Re:- Plot no 26/5 J. m. 3
Jamsheer Quarters.

NOTICE OF COMPLETION UNDER SECTION 187 (1) OF THE
CITY OF KARACHI MUNICIPAL ACT, 1933.

AMENDED
PLAN SHOWING ADDITIONS & ALTERATIONS IN
BUNGALOW ON PLOT NO. 26/5 J.M.3 SEHWANI
CO-OPERATIVE HOUSING SOCIETY
JAMSHED Q² SCALE 8=1

Diary sheet in respect of Building Regulation plans received.

AMENDED
PLAN SHOWING ADDITIONS & ALTERATIONS IN
BUNGALOW ON PLOT NO. 26/5 J.M.3 SEHWANI
CO-OPERATIVE HOUSING SOCIETY
JAMSHED Q5 SCALE 8-1

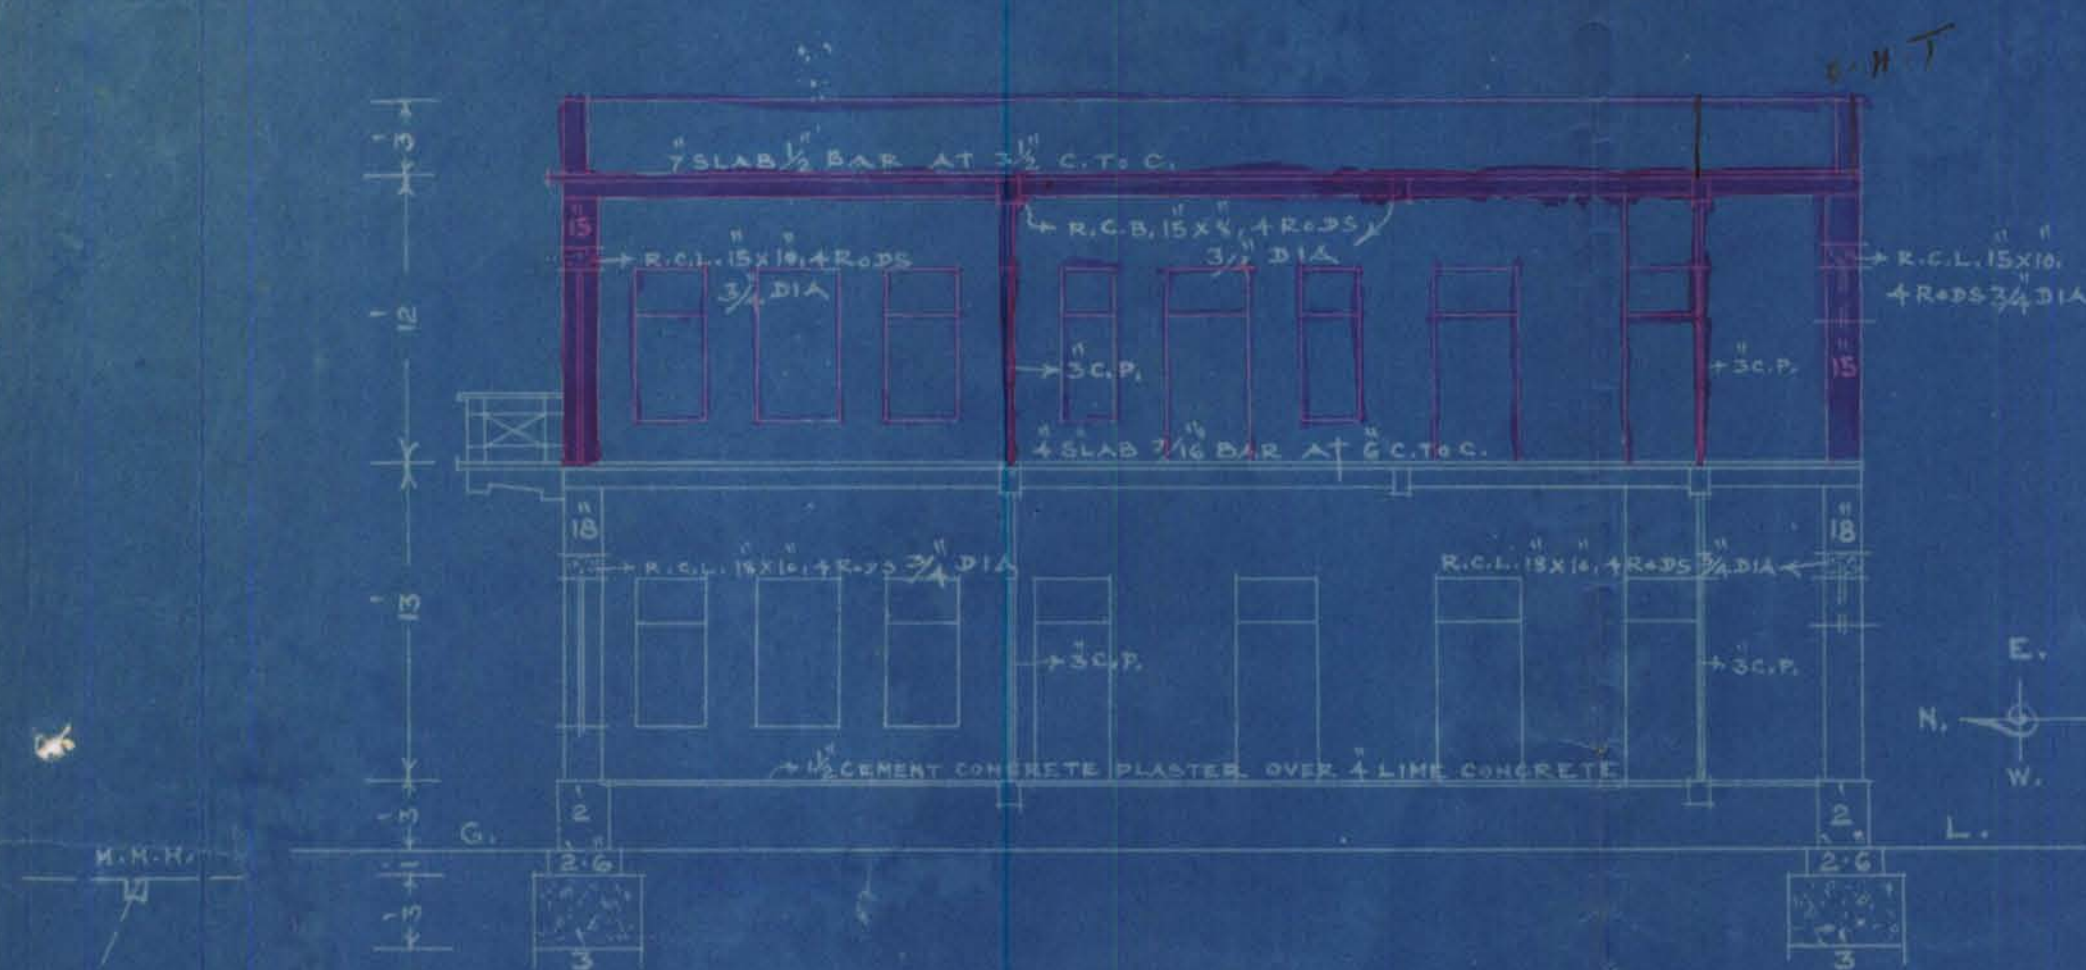
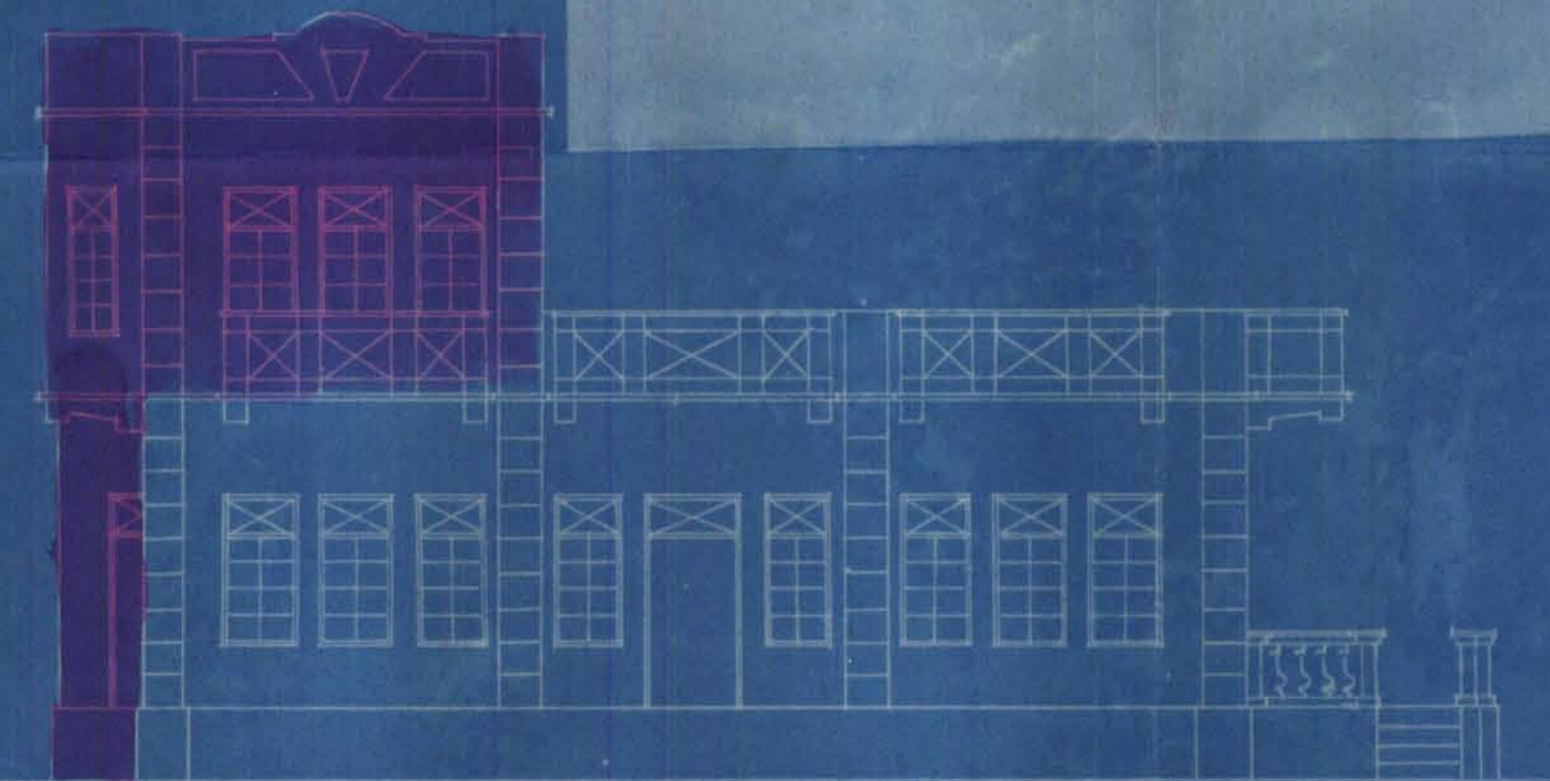
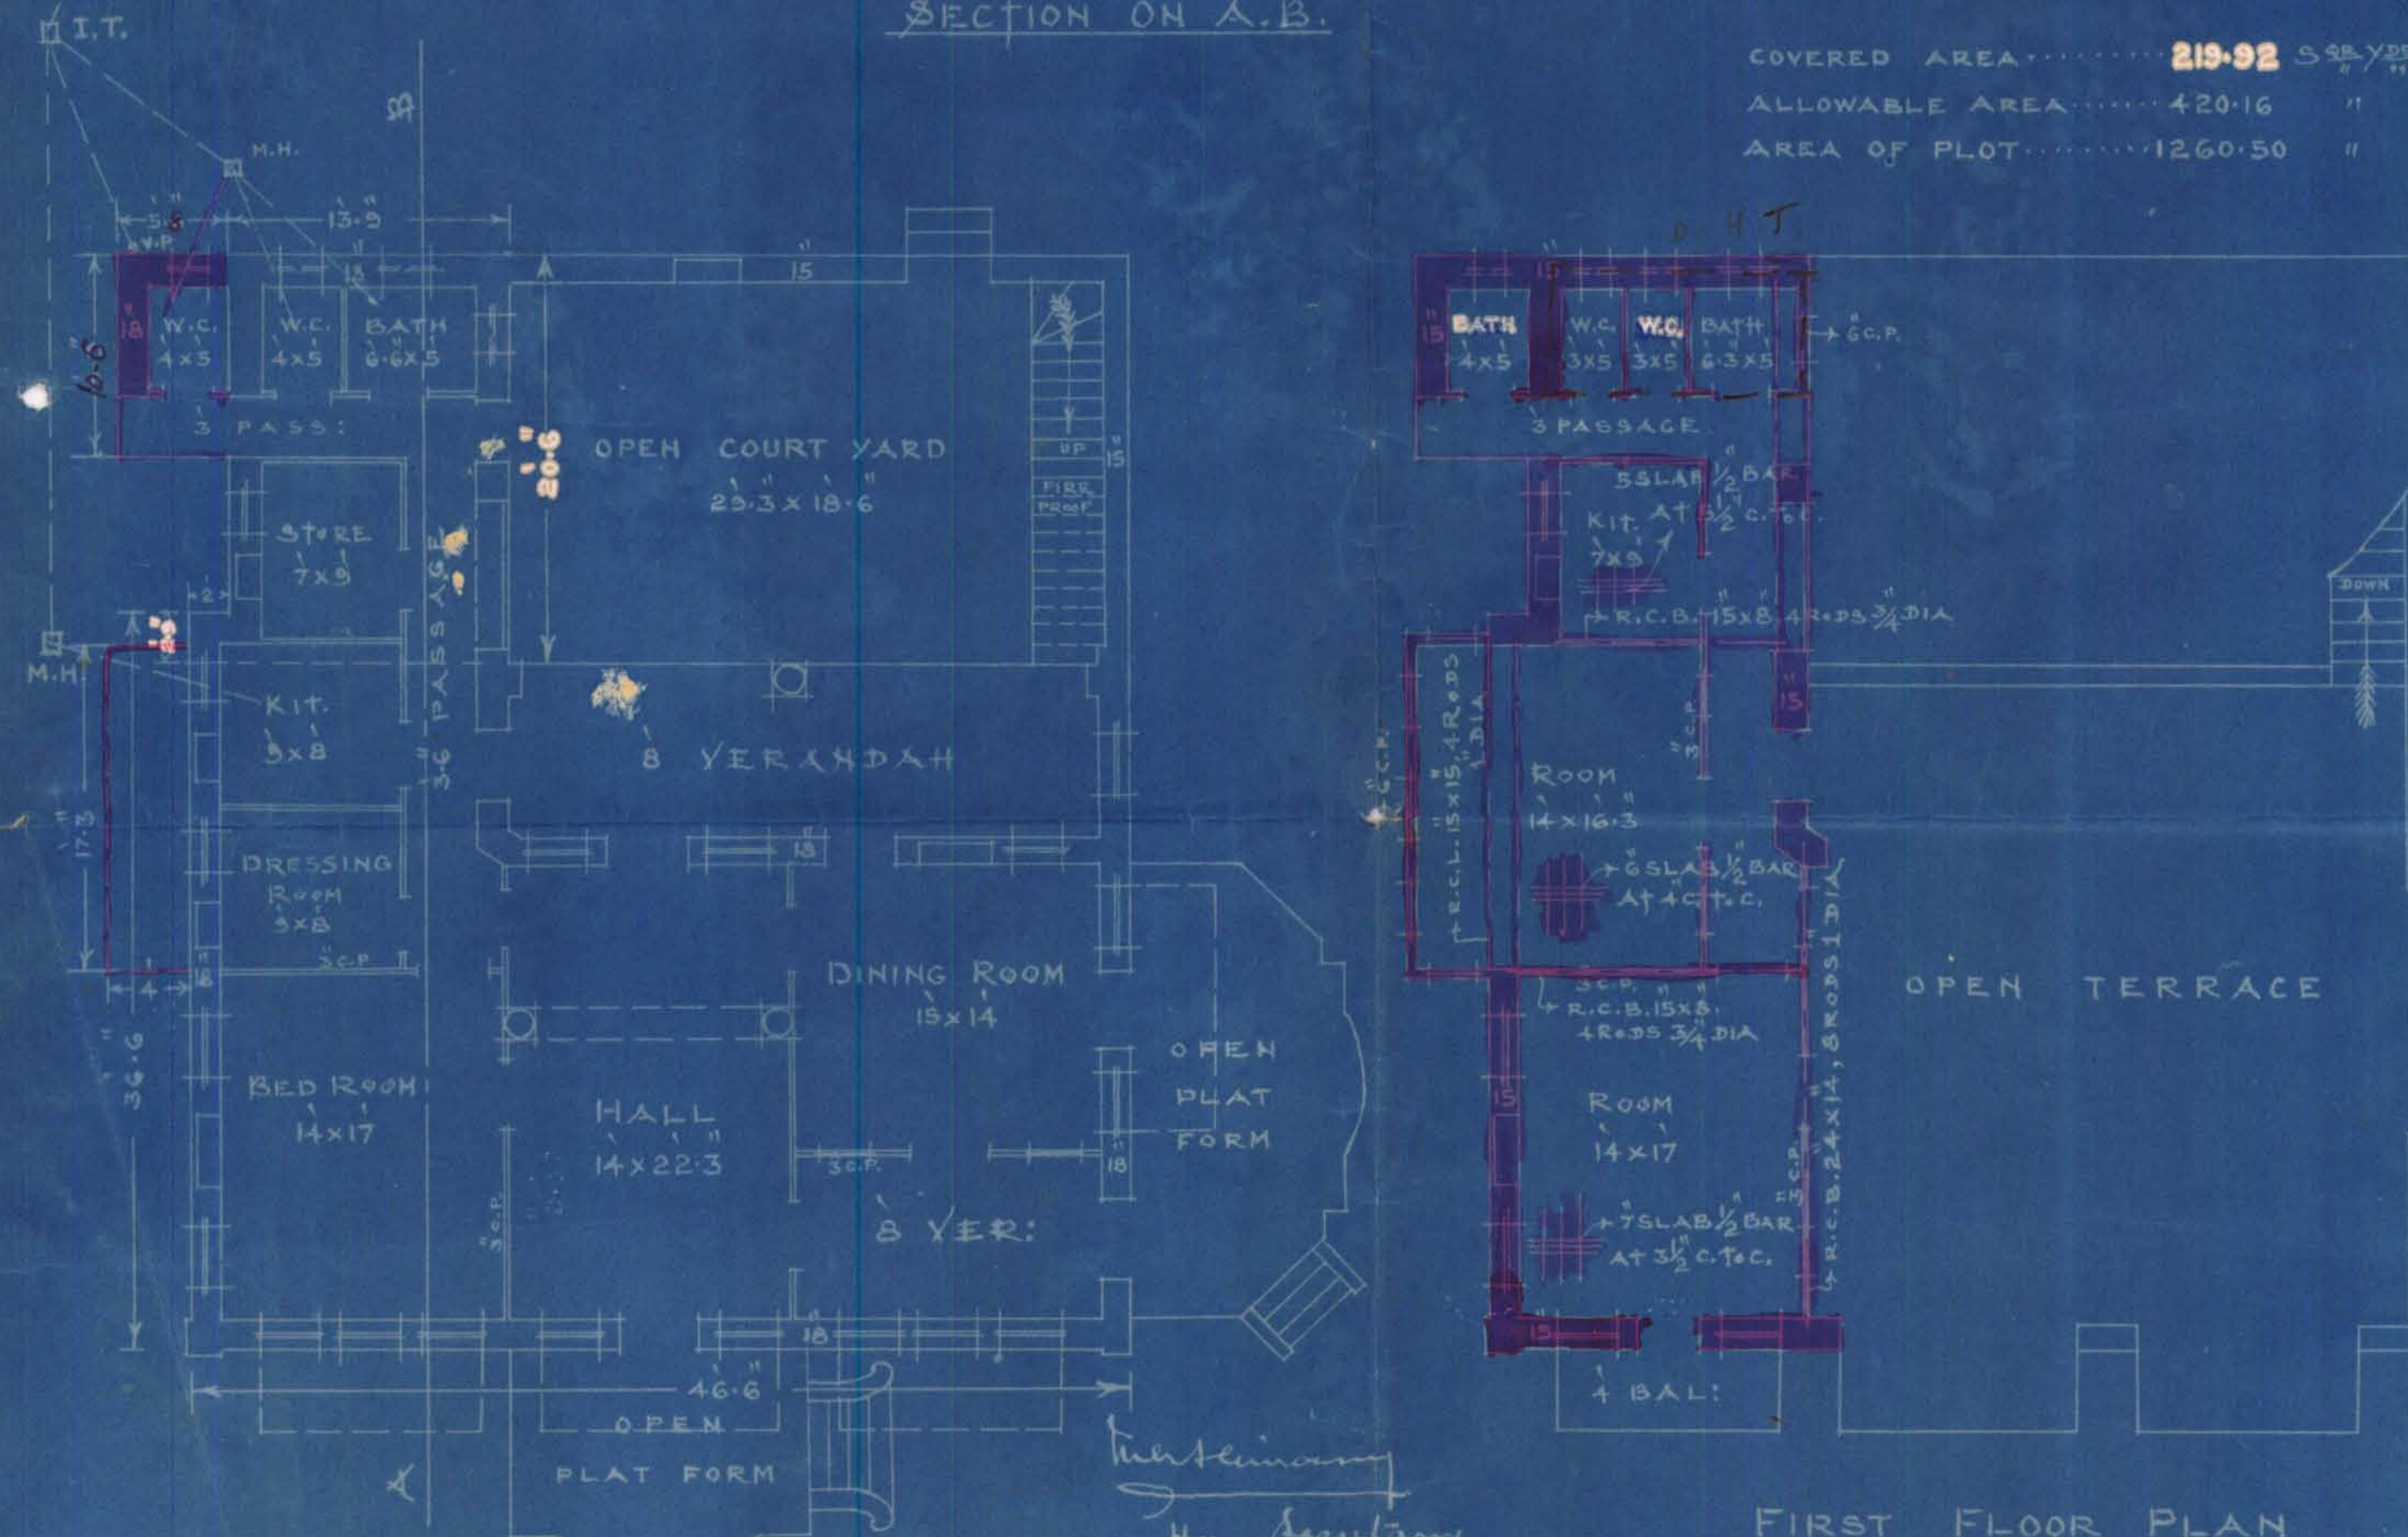
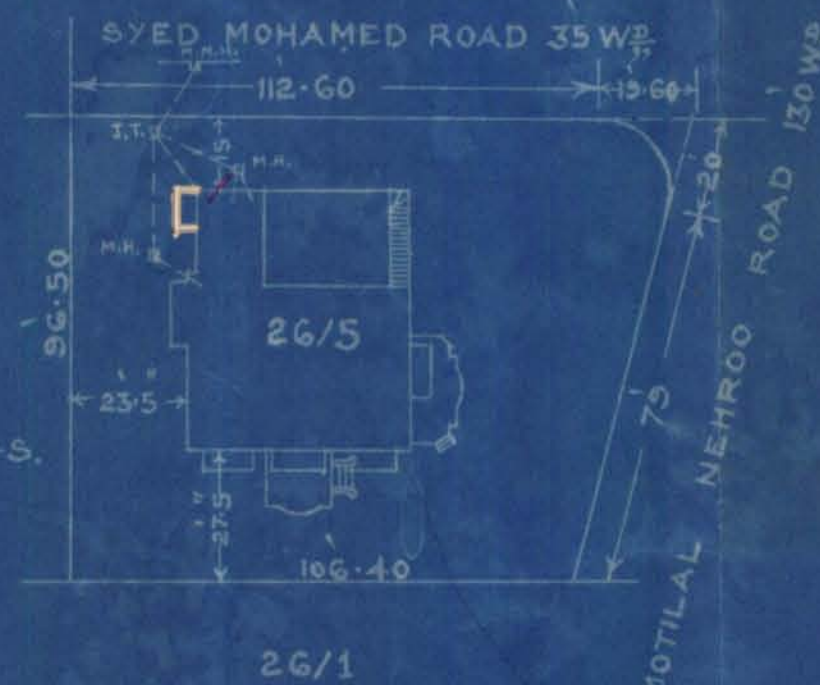
(1) Objection No.2 of this office letter dated
3rd November 1939 remains to be complied with.

With reference to your letter
no L.C.P 366/39 dated 2nd instant
I have to inform you that the
measurements have been jointly
checked and the corrections made
in the area calculations.

*Measurements were taken along with the
architect & the built-up area has
been corrected in the plan itself.
The corrected built-up area is 220.57 sq yds.
J.M.
8/12*
